TO: Advisory Board on Radiation and Worker Health Work Group on TBD-6000
FROM: Robert Anigstein and John Mauro, SC&A
SUBJECT: Review of Appendix BB, Revision 1
DATE: December 10, 2014

Review of “Site Profiles for Atomic Weapons Employers that Worked Uranium Metals Appendix BB – General Steel Industries,” Revision 1

Figure 1. Detail from Plant Layout, Showing Betatron Buildings (GSCC 1969)

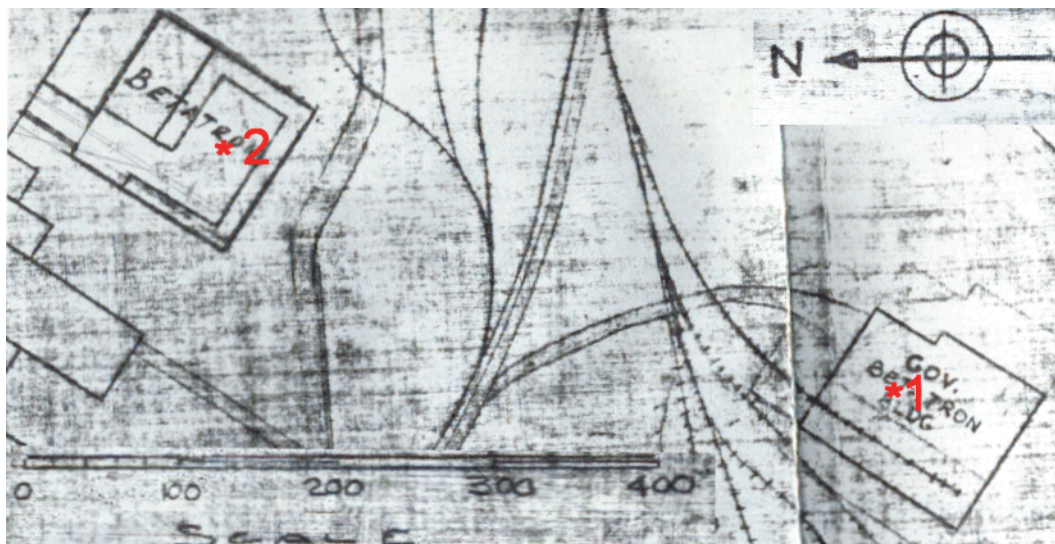
This conclusion is further bolstered by the fact that the limiting scenario for external exposure during 1963–1966, the years during which both betatrons were operating, is the layout man. In this scenario, the worker is assumed to be located just outside the New Betatron Building, in the area shown in the upper-left-hand corner of Figure 1. Any neutrons from the old betatron reaching this location would be attenuated by passing through the southwest shield wall of the New Betatron Building, in addition to being greatly reduced by the distance. We nevertheless recommend that the revised Appendix BB should take note of this potential contribution to resolve any questions regarding this issue.
